Task 30
Sump 1727
Interim Response Action
Alternatives Assessment
Final Report
Version 3.2

July 1988
Contract Number DAAK11-84-D-0016

APPENDIX A
COMMENTS AND RESPONSES TO THE
TASK 30 SUMP 1727 INTERIM RESPONSE ACTION
ALTERNATIVES ASSESSMENT DRAFT FINAL REPORT
MAY 1988

Figure 3.3-1
POTENTIAL SOURCE AREAS
 SOURCE: ESE, 1987

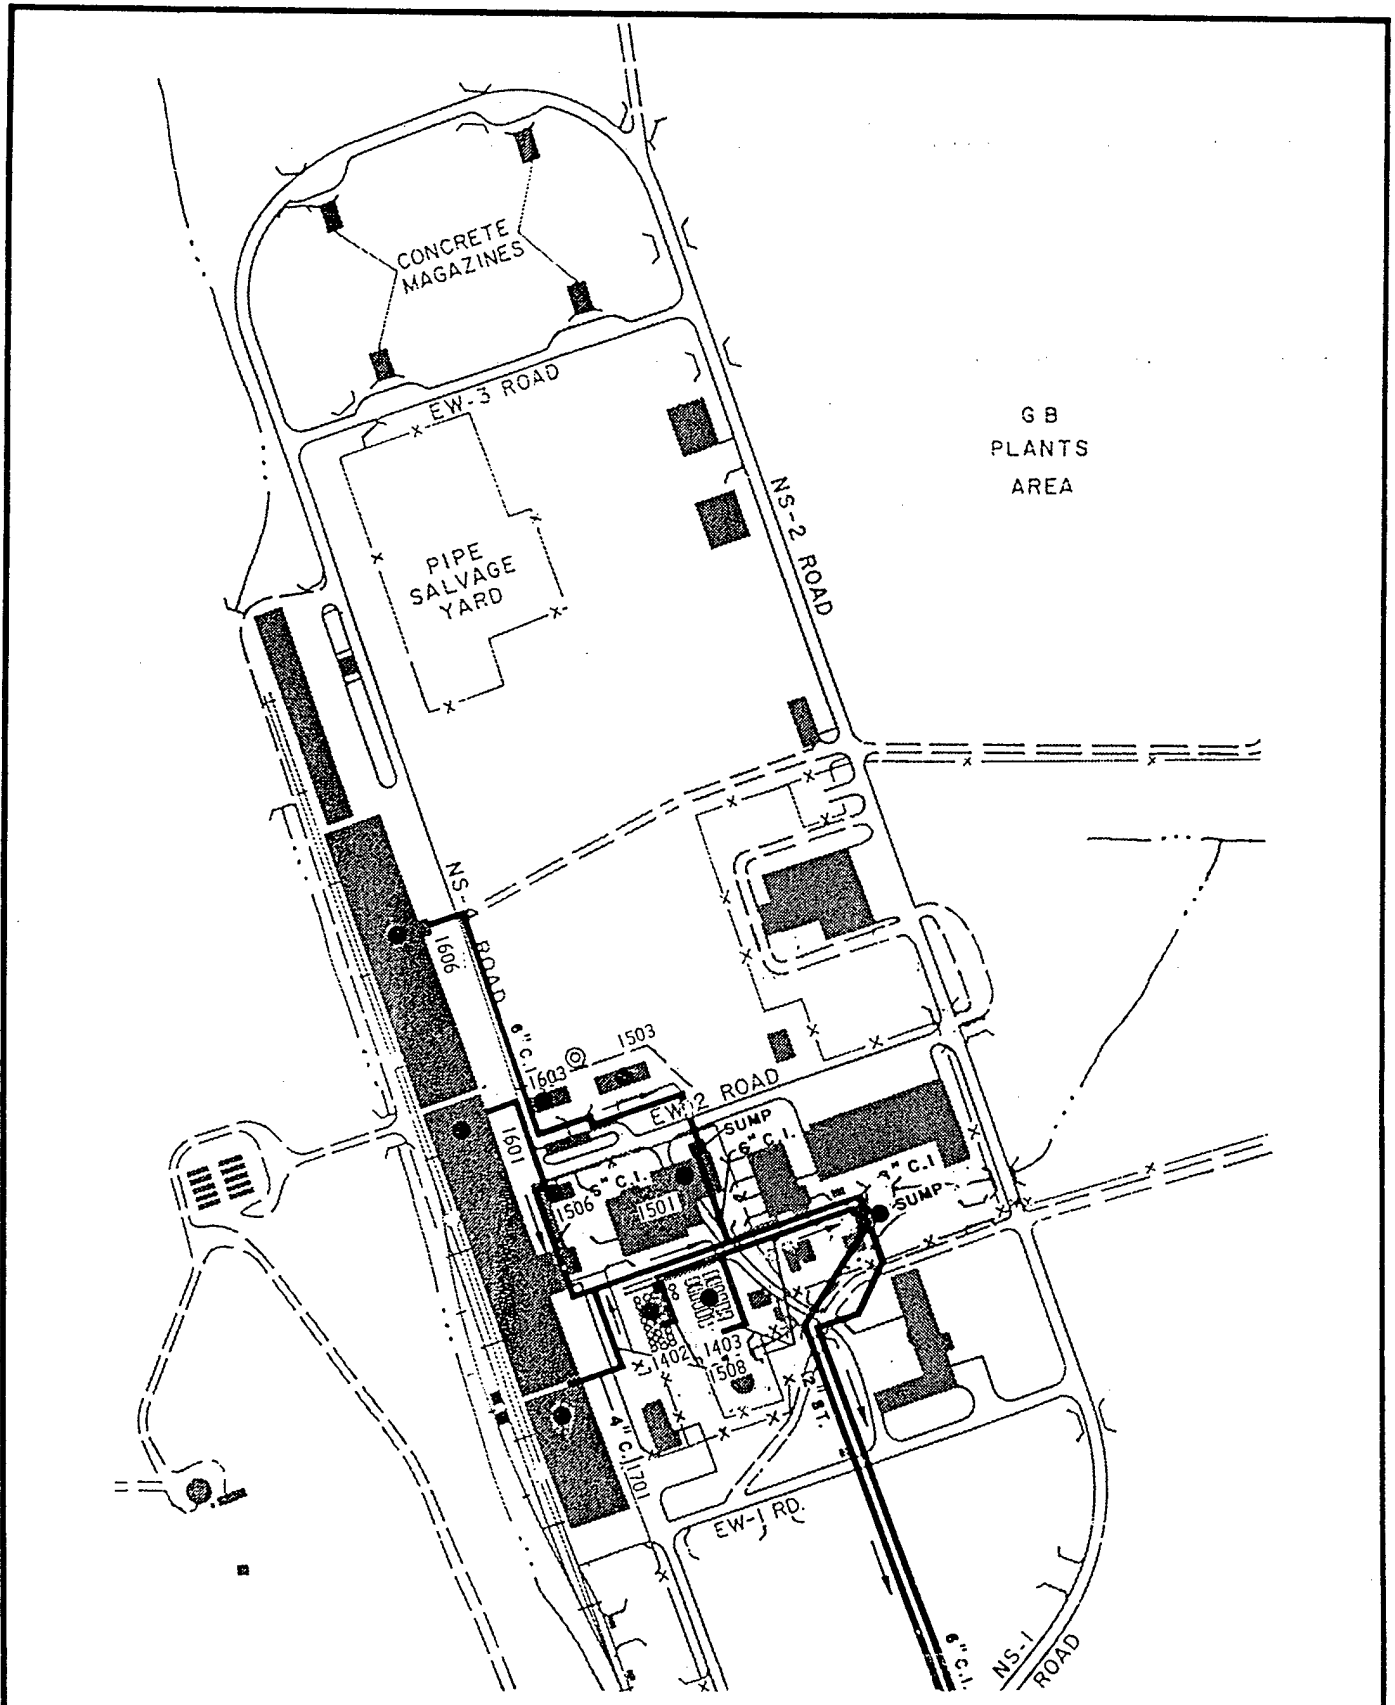
5. Page 3-11, Figure 3.3-1.
